# MY02 MONITORING REPORT

Round Hill Branch Restoration Site  
Buncombe County, North Carolina  
French Broad River Basin - 06010105

DMS Project #100066

## MEMORANDUM

# Round Hill Branch Creek Restoration Site Hydrograph Stream Gauge T1

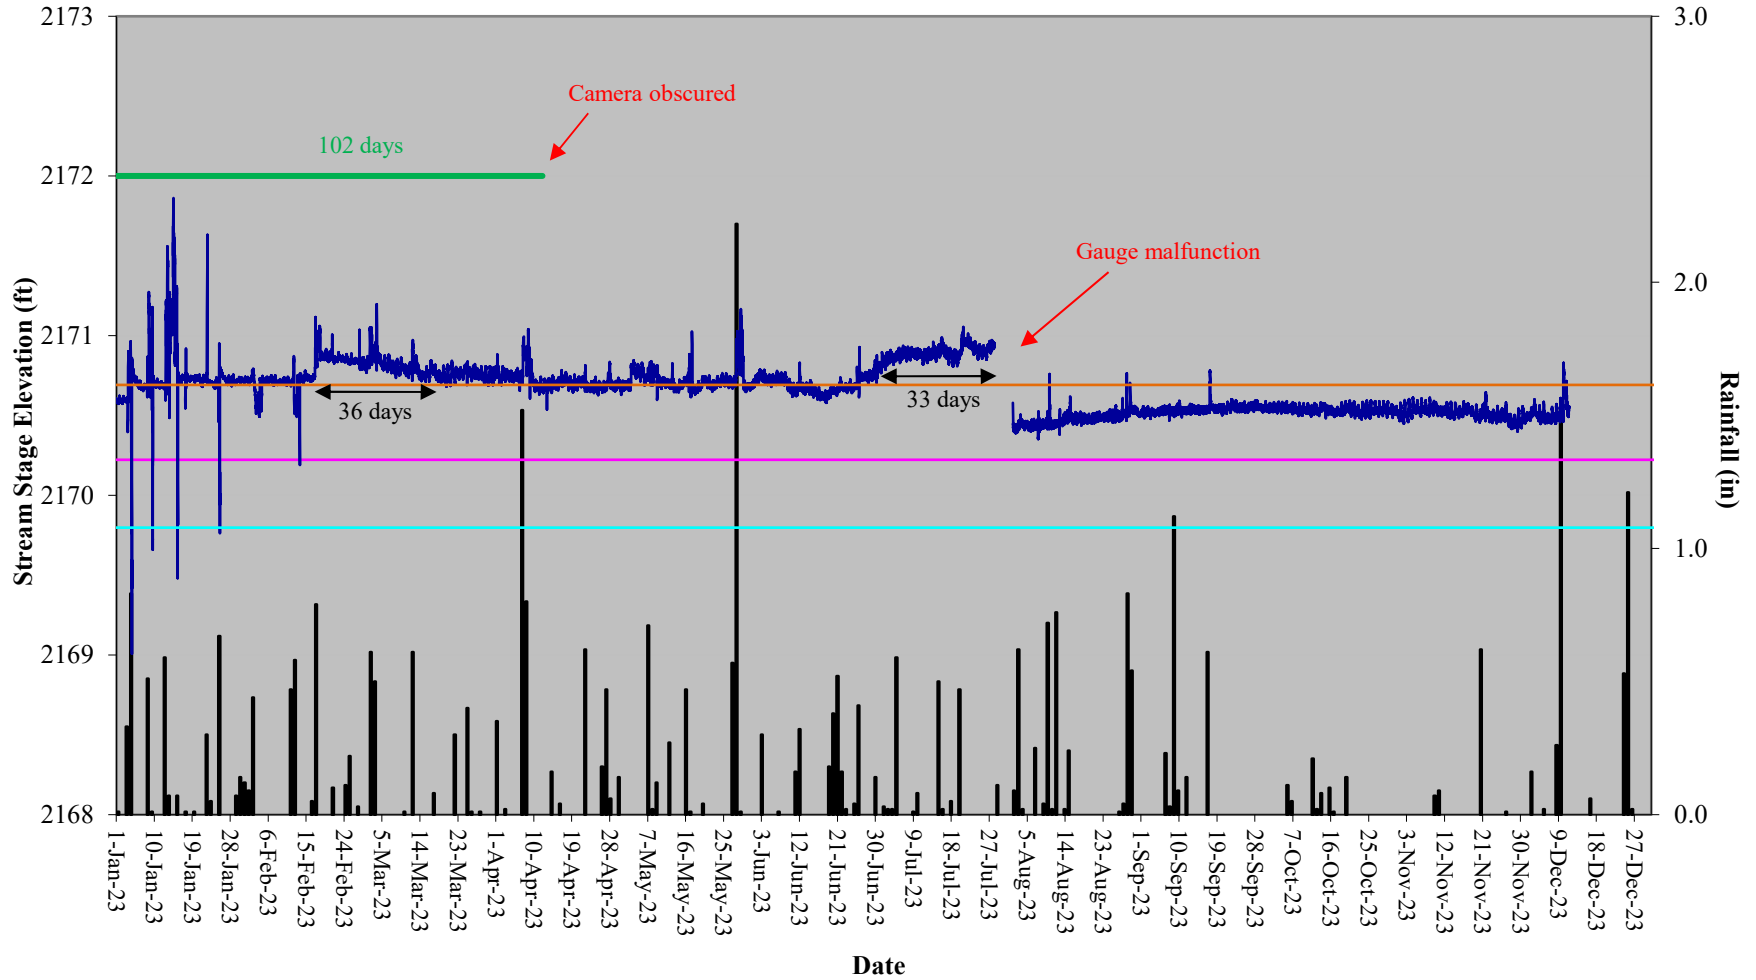
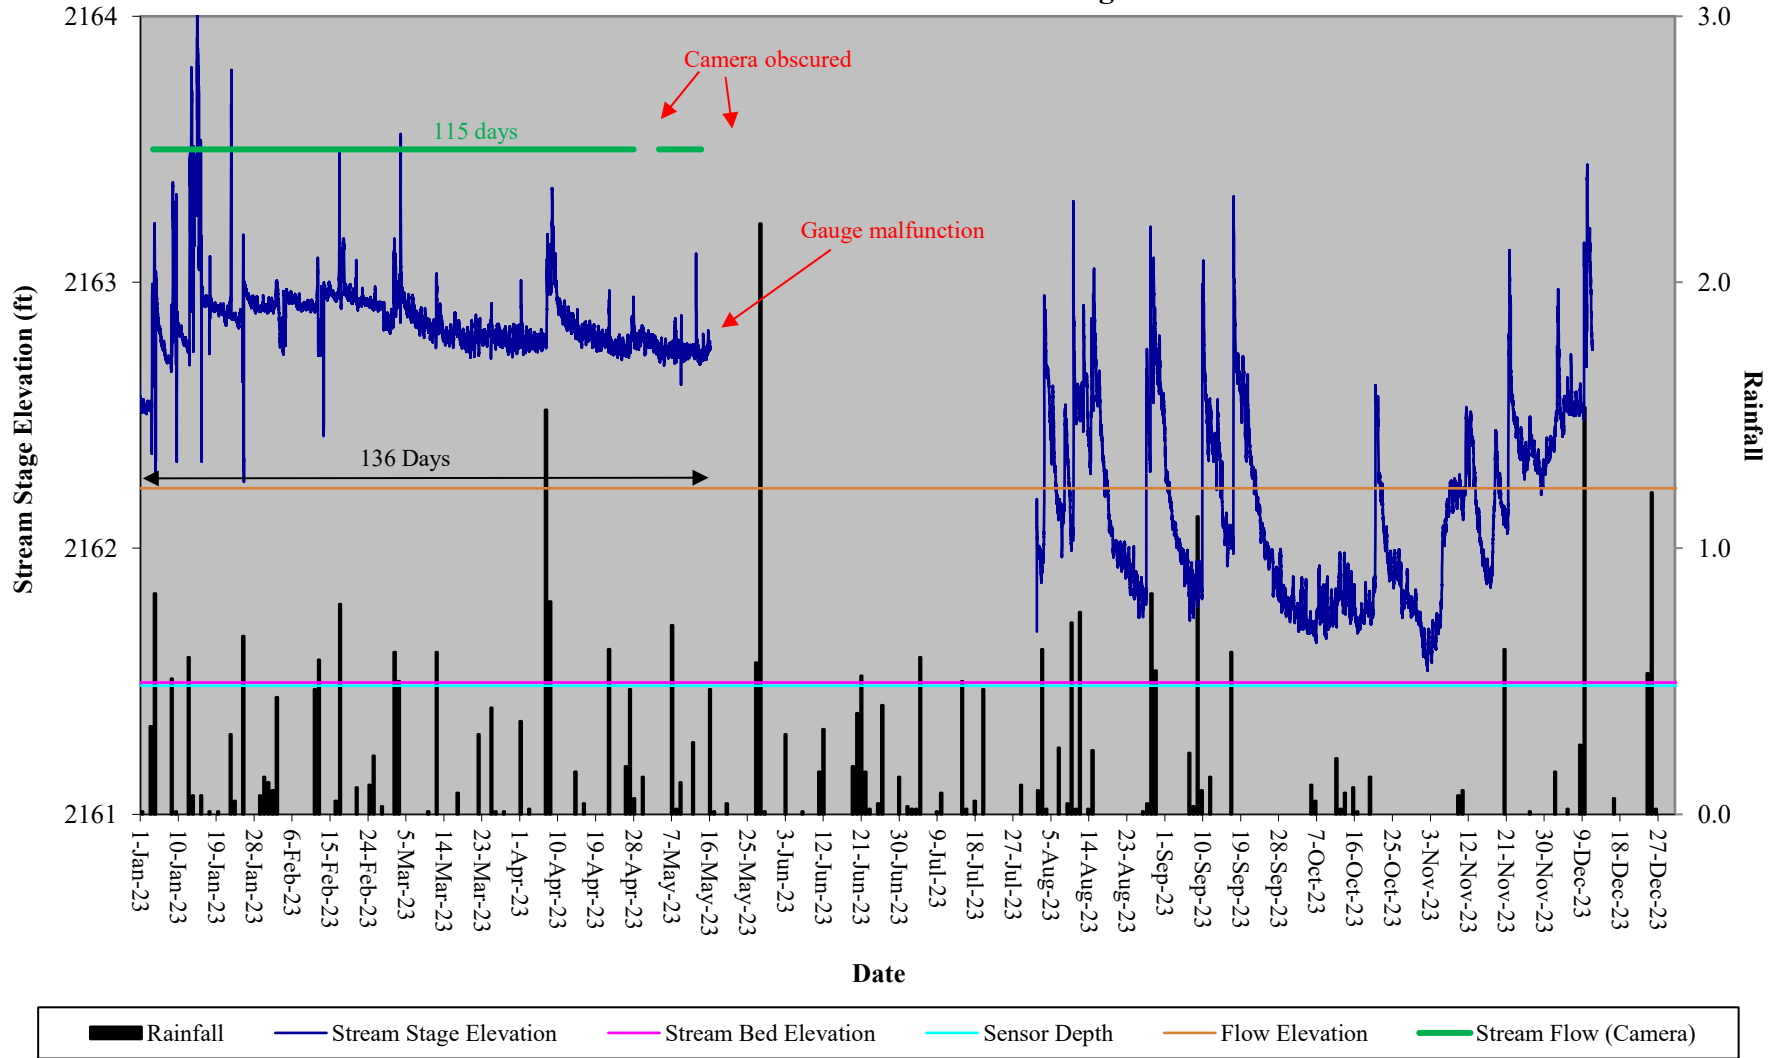
6. T1 and T2 Hydrograph: Recommend adding consecutive days for camera observation for each graph.

*KCI Response: This change has been made.*
